STAFF ANALYSIS

CASE NO.:	Z-26-1247887	File ID #: 2026-0449
Address:	705 & 711 Hillmont Avenue, Decatur, Georgia	Commission District: 04 Super District: 06
Parcel ID(s):	15-248-07-017 & 15-248-07-020	
Request:	Rezone properties from the C-1 (Local Commercial) Zoning District and to the R-60 (Residential Small Lot -60) Zoning District to construct a new single-family residence.	
Property Owner(s):	William McGrier	
Applicant/Agent:	Ray Bachan / My Next Home Pro, LLC	
Acreage:	0.15 acre	
Existing Land Use:	Single-Family Home	
Surrounding Properties:	North: Commercial (within City of Avondale Estates) South: R-75 East: R-75 West: R-75	
Adjacent Zoning:	R-75 (Residential Small Lot-75)	
Comprehensive Plan:	Commercial Revitalization Corridor (CRC) Consistent <u>X</u> Inconsistent

STAFF RECOMMENDATION: APPROVAL WITH CONDITIONS.

SHEET
C-002

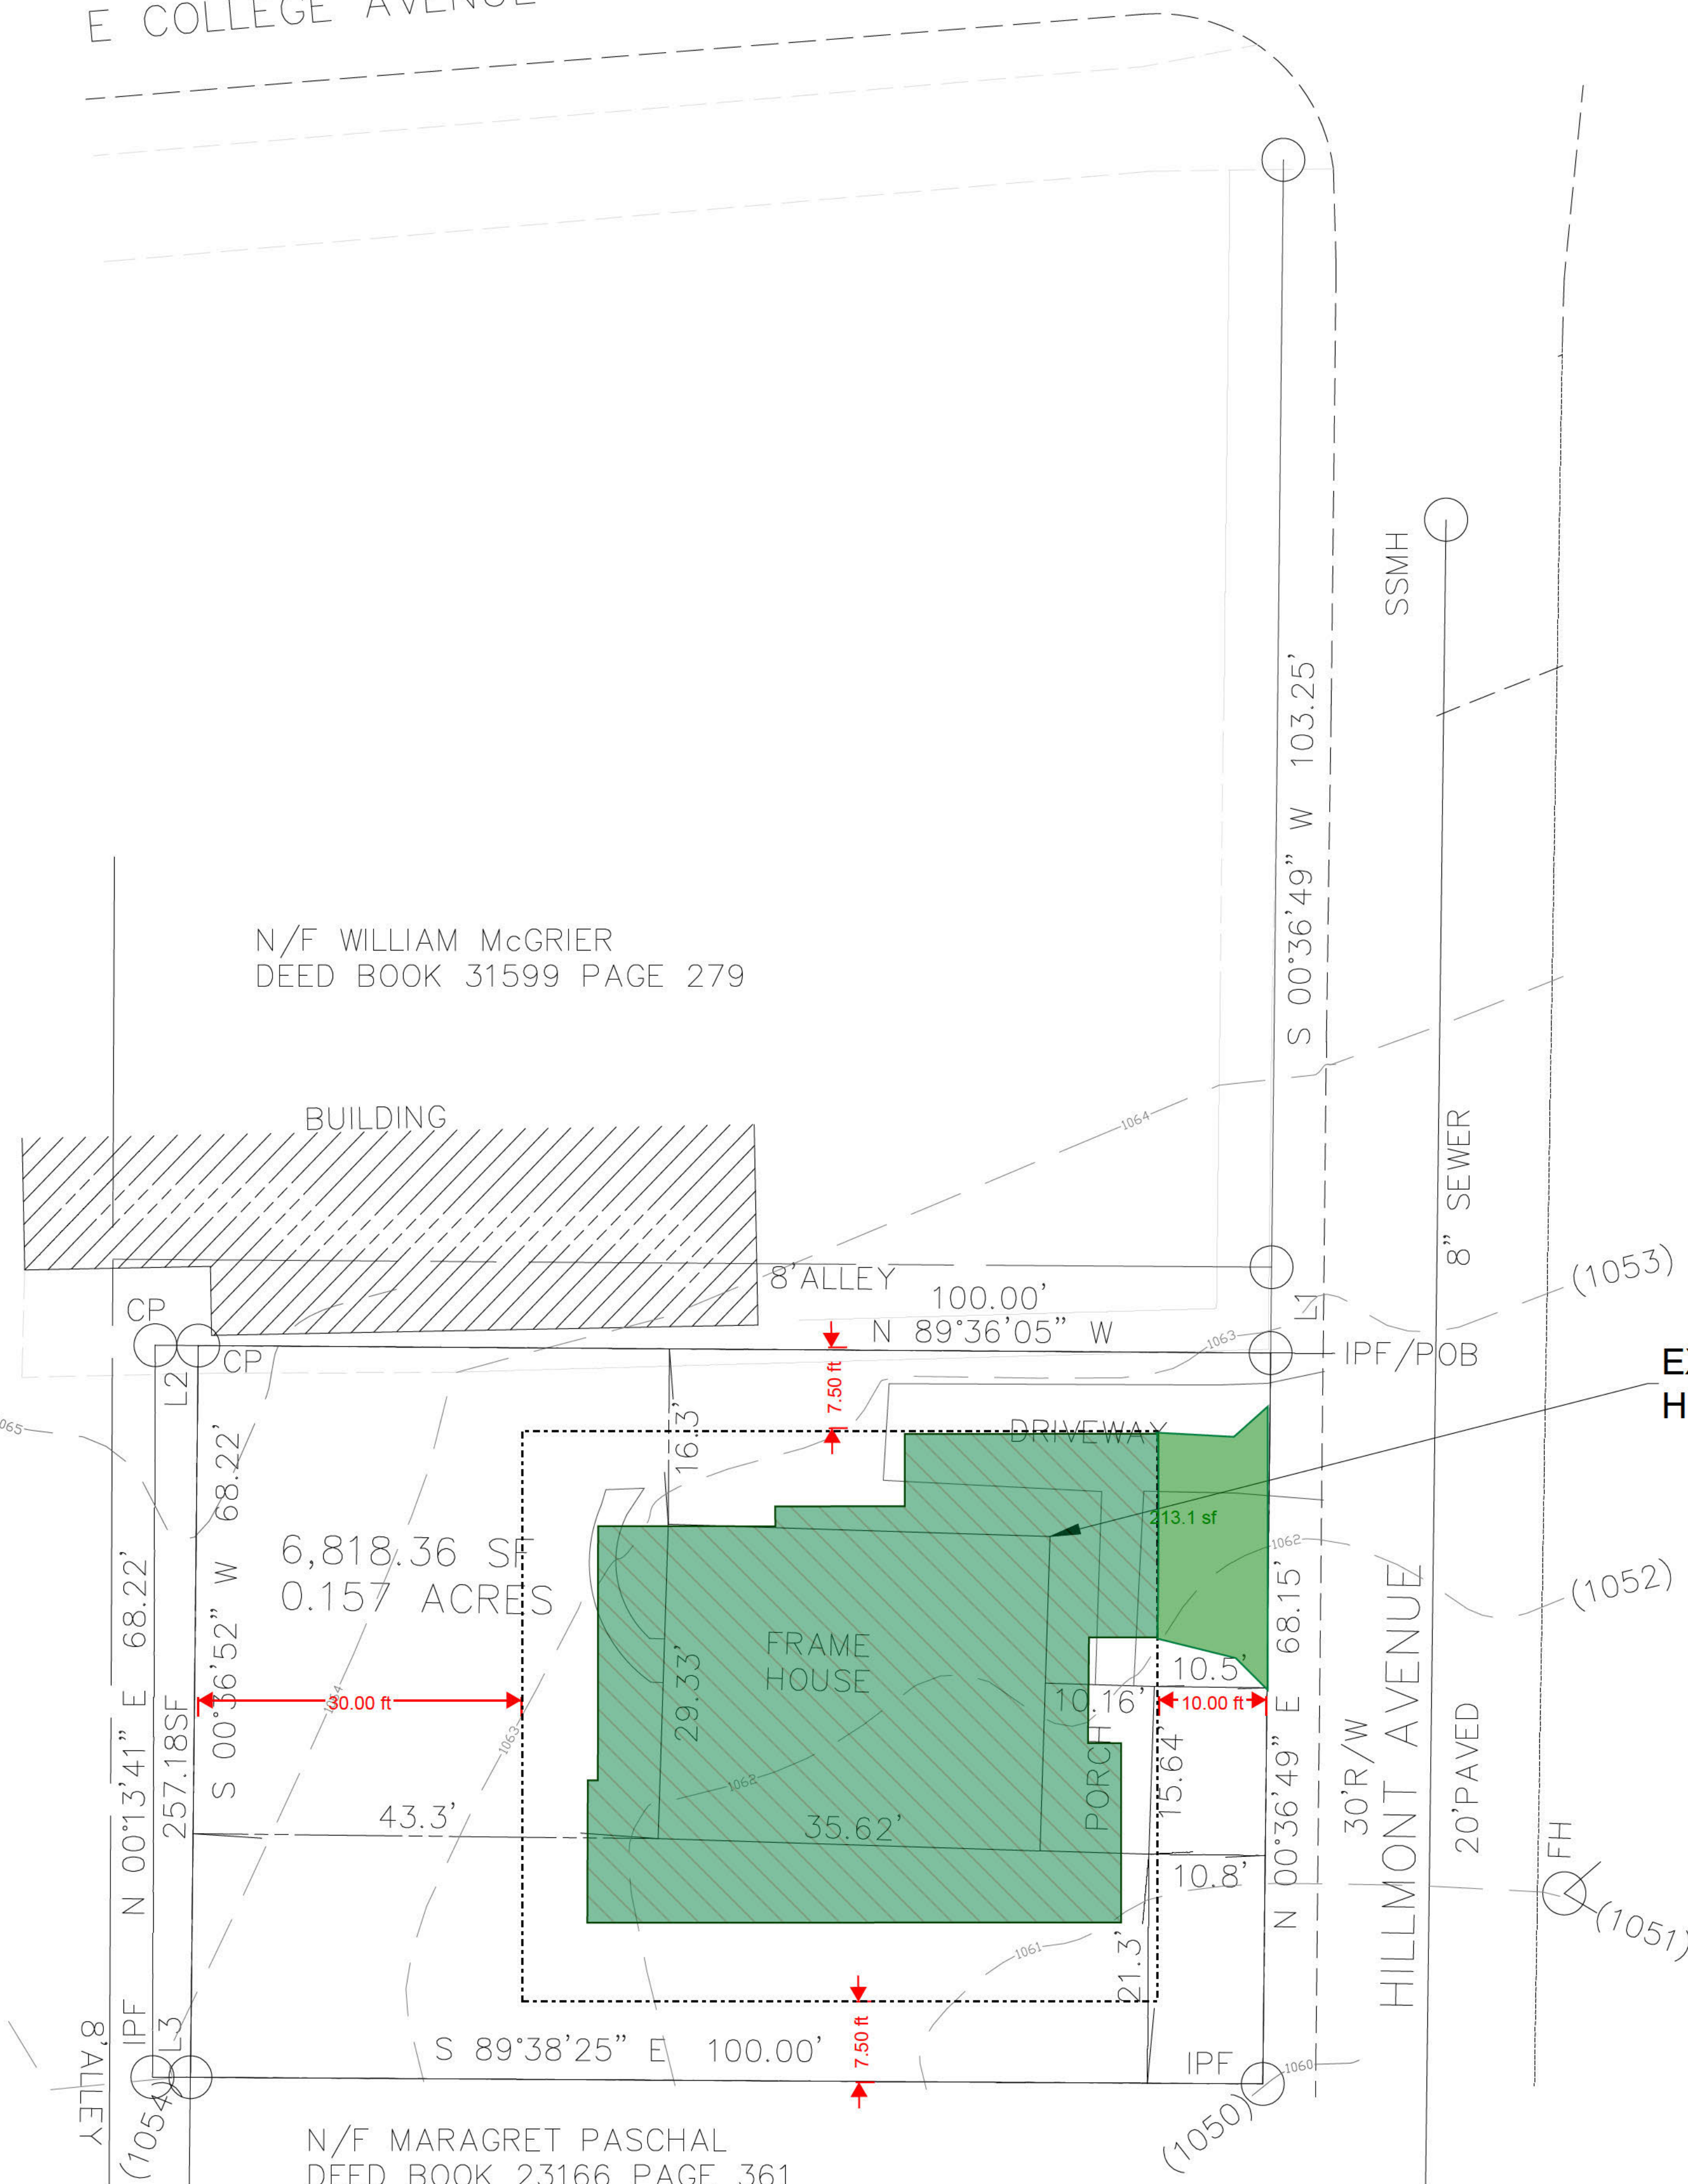
The proposed site plan and architectural plans submitted by the applicant displays a modern three (3)-story single-family house that appears to meet R-60 *Dimensional requirements* of Section 27-2.8.3 (*Table 4.1*). The house plans indicate a 3,639 square-foot heated area, an attached 474 square foot unheated garage, a 217 square-foot covered rear patio, and a partial roof deck patio on the 3rd floor of the home. Section 27- 2.8.3 and Table 4.1 of

the Zoning Ordinance state that the minimum lot size is 15,000 square feet with a maximum lot coverage of 35 percent. The minimum house size is 2,000 square feet heated along with a maximum height of 35 feet, with setbacks of 10 feet in front (with alley access), 7.5 feet on each side, and a 30-foot rear setback. There are no proposed variances.

Hillmont Avenue is classified as a local roadway. Please refer to the requirements in Zoning Code 5.4.3 and Land Development Code 14-190. Requires a right of way dedication of 27.5 feet from centerline OR such that all public infrastructure is within right of way, whichever greater. Requires a 5-foot landscape strip with a 5-foot sidewalk. It requires pedestrian scale streetlights. (hefowler@dekalbcountyga.gov).

SHEET TITLE:
PROPOSED
FRONT ELEVATION

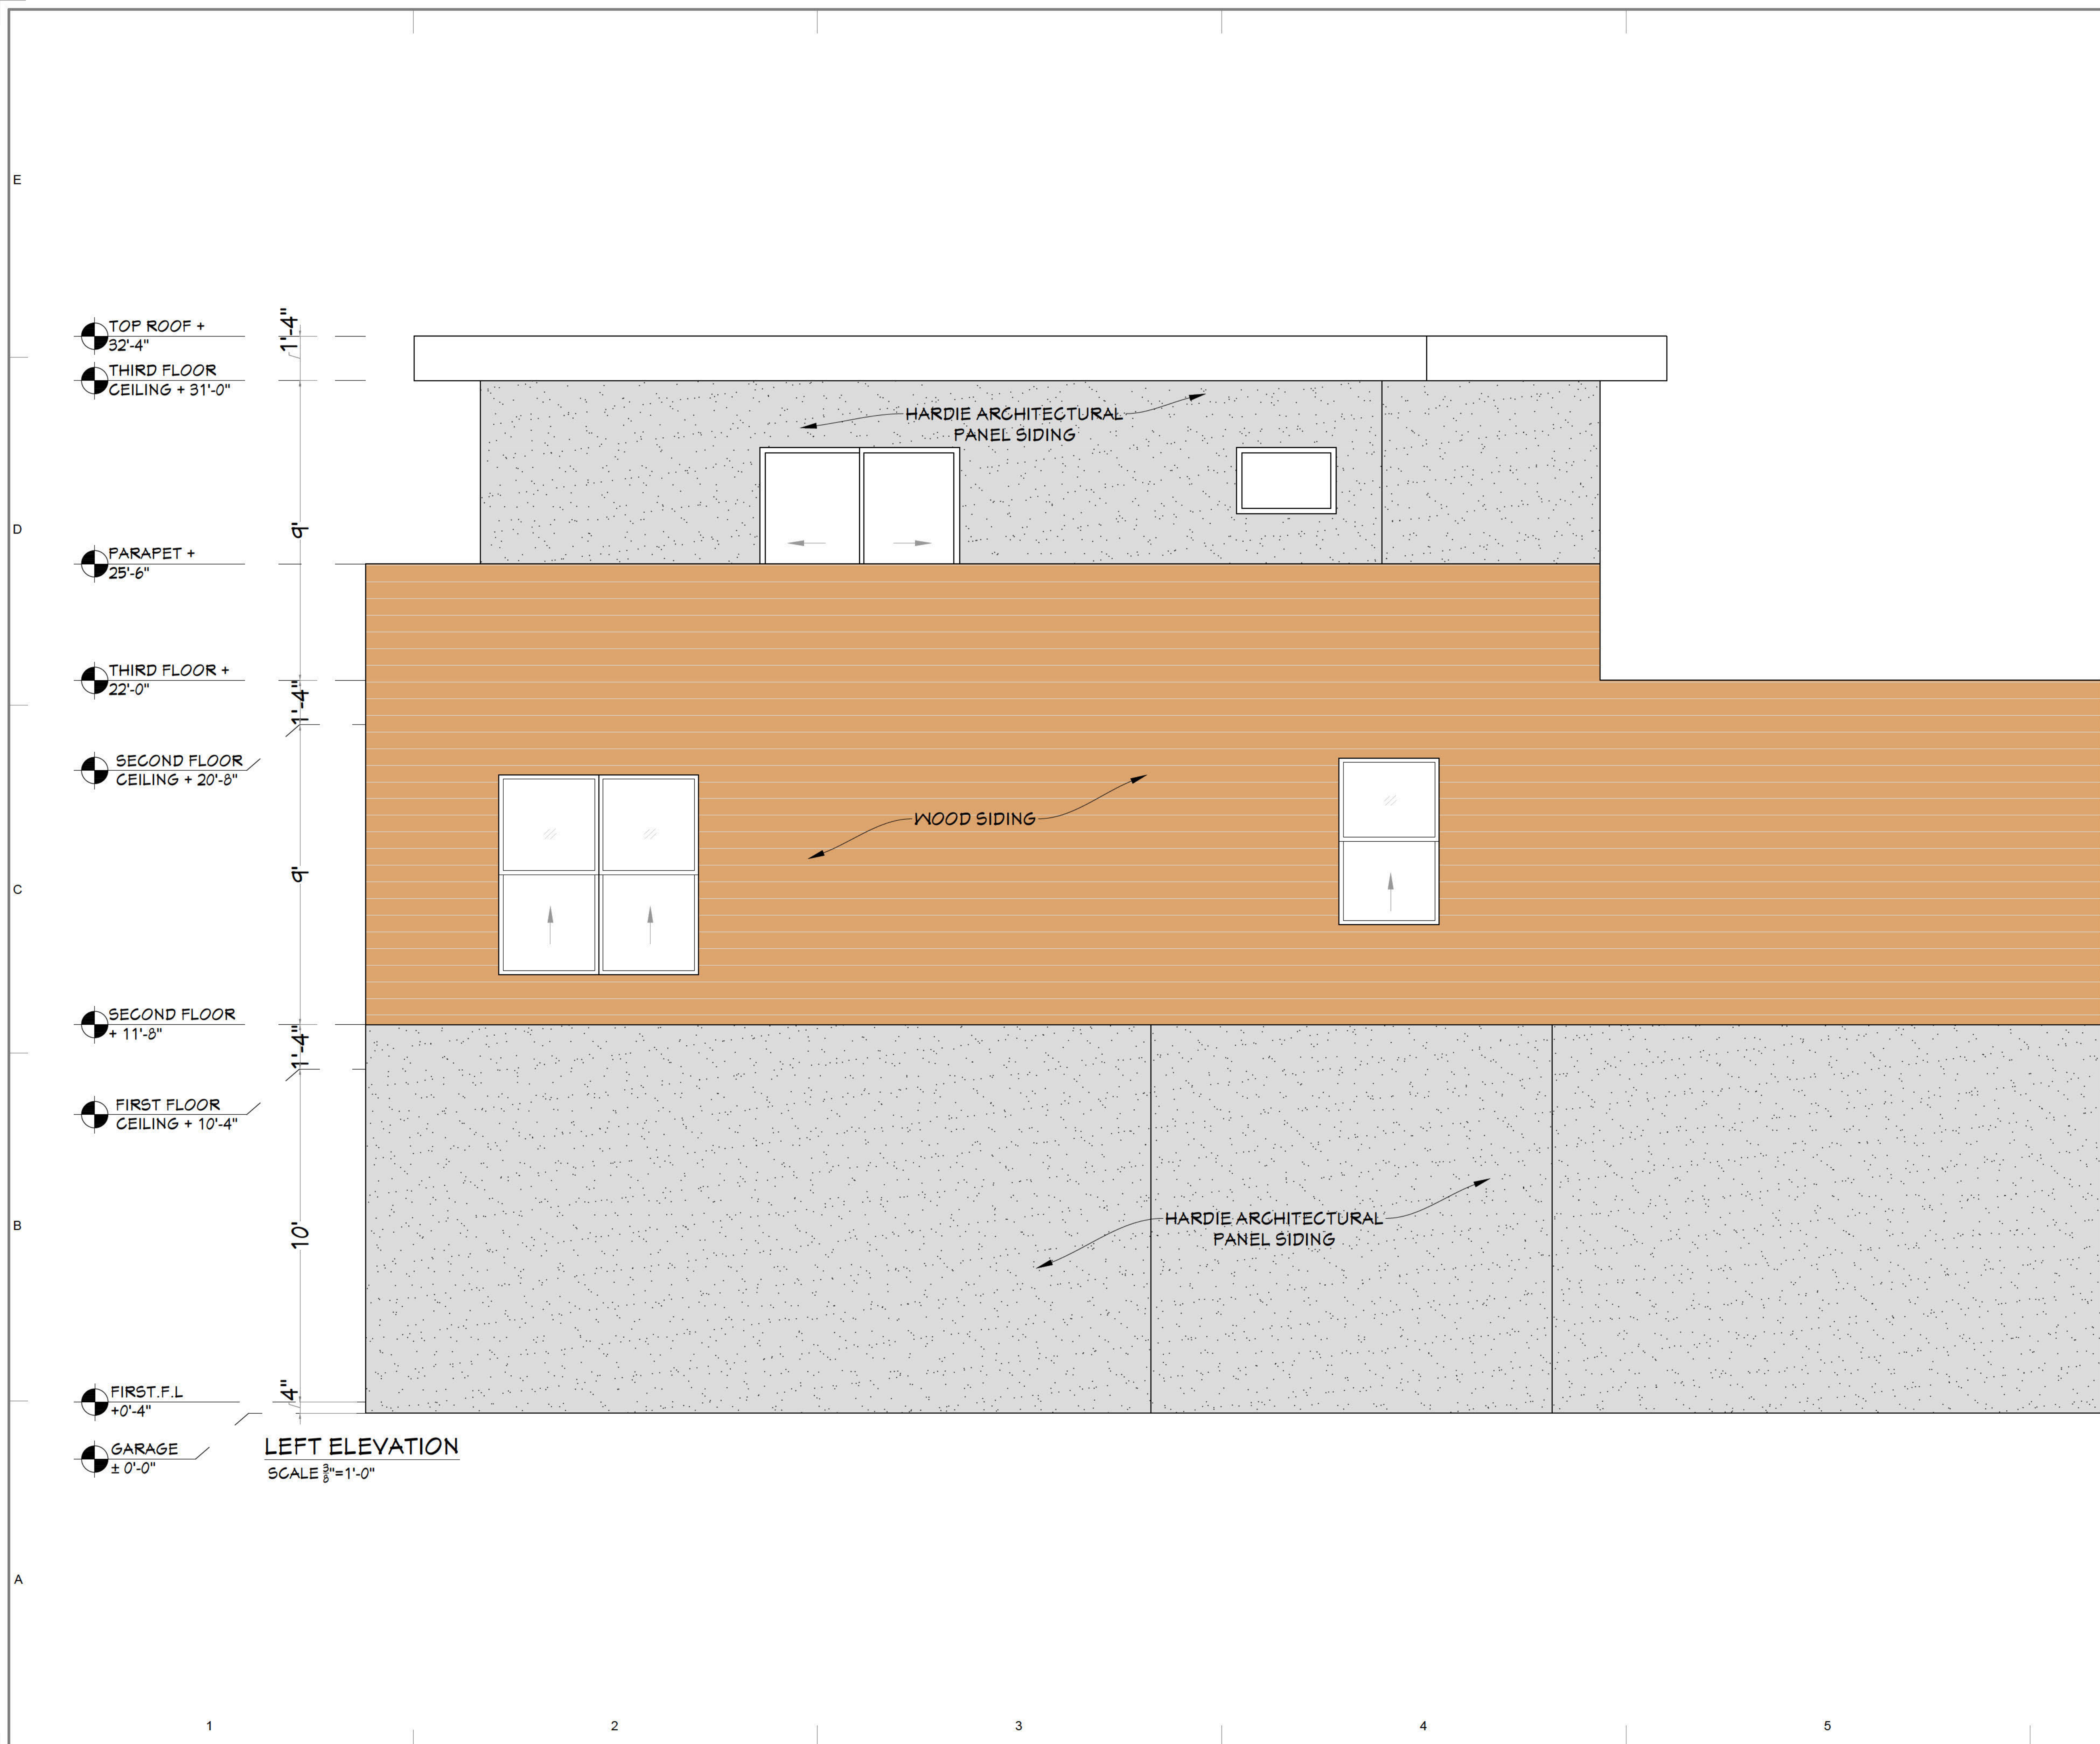
While the rezoning is consistent with the neighborhood, the proposed architectural design may not align with the existing development pattern along Hillmont Avenue. Accordingly, considerations to the re-design have been proposed by Staff to better align with the architectural character of the TN Character Area. Therefore, upon review of Section 5.3.4 (Rezone criteria A-N) of the Zoning Ordinance, Staff recommends ***"Approval with the following conditions"***:

- 1) The architectural plan will be redesigned to reflect a design that satisfies the intent and goal of the Traditional Neighborhood (TN). Such design will require written approval from the Planning Deputy Director prior to any permit.
- 2) A 5-foot landscape strip and 5-foot sidewalk must meet the requirements of Section 5.4.3 (Streetscape Elements and Dimensions) of the Zoning Ordinance, prior to the issuance of the Certificate of Occupancy (C/O).
